# 2014 - 2016 Corvette: Service Bulletin: #PI1116A: Door Rattle Noise from Outside of Vehicle During High Radio Volume or High Bass Levels - (Sep 14, 2016)

<b>Subject:</b>	Door Rattle Noise from Outside of Vehicle During High Radio Volume or High Bass Levels
<b>Models:</b>	2014-2016 Chevrolet Corvette
<b>Attention:</b>	This PI also applies to any of the above models that may be Export from North America vehicles.

This PI has been revised to remove a breakpoint and add the 2015-2016 Model Years. Please discard PI1116.

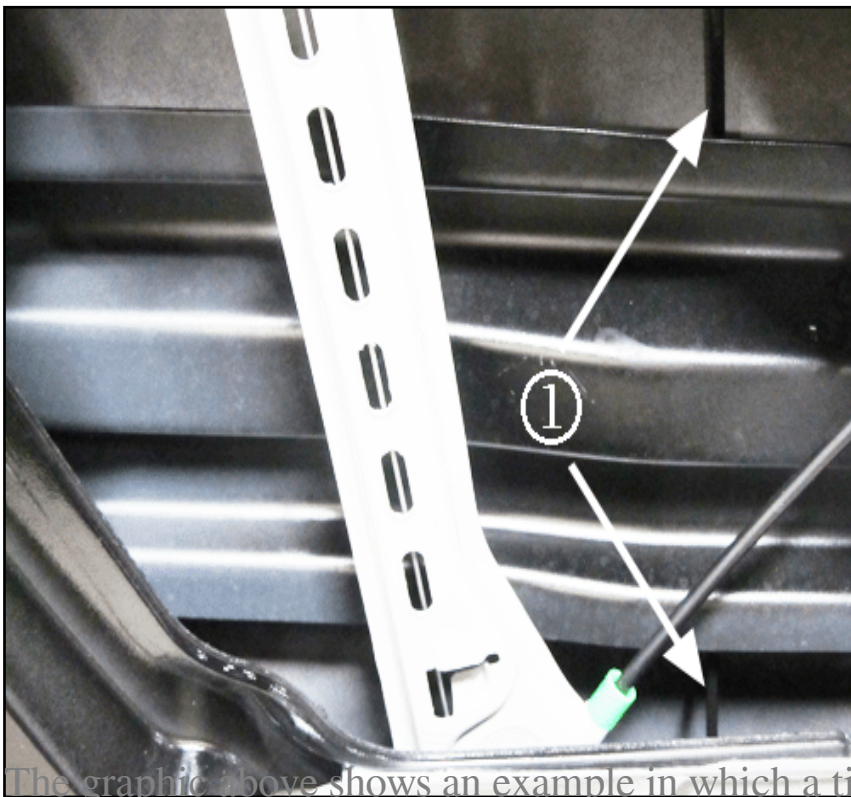
The cause of this condition may be voids in adhesive (1), leaving gaps between the inner door beam and the door skin.

The graphic above shows an example in which a tie strap (1) was passed through a 15-20 cm (6-8 in) length gap where the adhesive was missing towards the center of the door.

This can also occur in the front and/or rear area of the door beam; with the condition sometimes more evident in the front area (shown above) where the radio speaker is mounted.

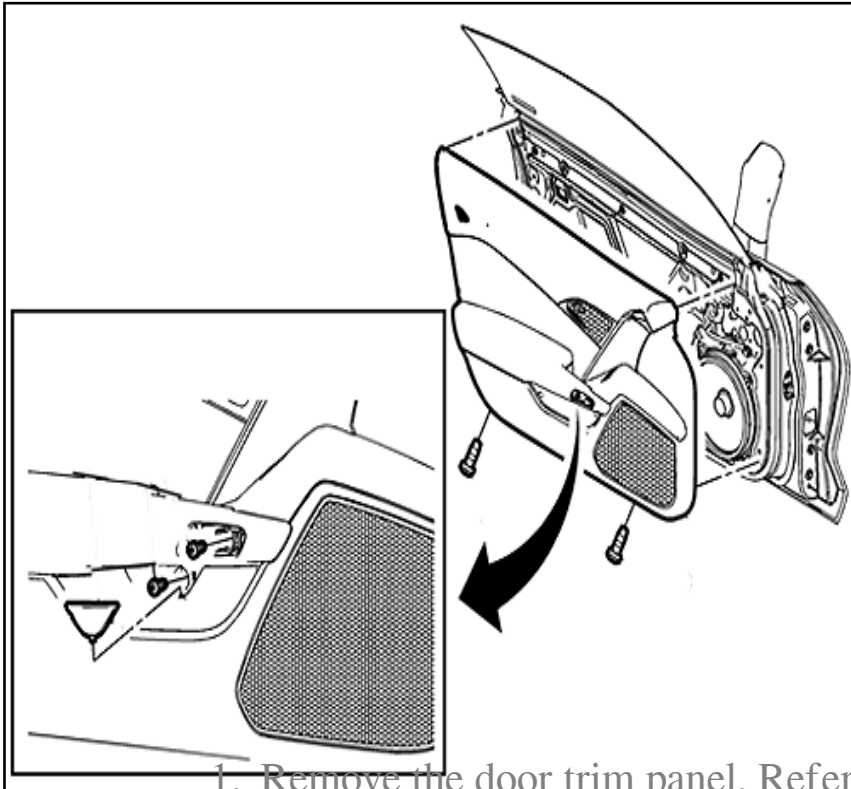
Inspect the front side door beam and door skin gap for voids and add a bead of butyl ribbon sealer in those areas following the steps below:

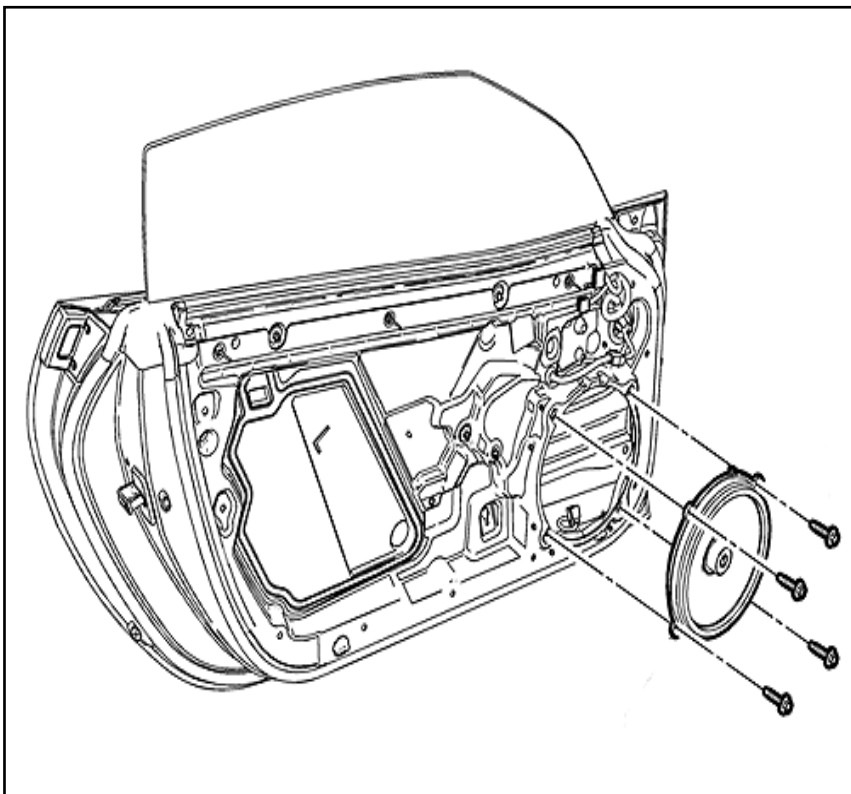
2. Peel down the door water deflector enough to access

1. Remove the front door lower speaker. Refer to *Radio*

2. Inspect the gap between the inner door beam and door

**Tip:** Use of a trim stick, or equivalent tool, may help to work the sealer into the gap.

1. Add a bead of \*3M Windo-Weld™ Ribbon Sealer P/N 08611, or equivalent, to the areas where adhesive is missing. Work the sealer so there is a continuous bead in the gap from the rear of the door beam to the front.
2. Reinstall the front door lower speaker and test to make sure the rattle noise is eliminated. Refer to *Radio Front Side Door Speaker Replacement* in SI.
3. Reposition the water deflector and reinstall the door trim panel. Refer to *Front Side Door Trim Replacement* in SI.
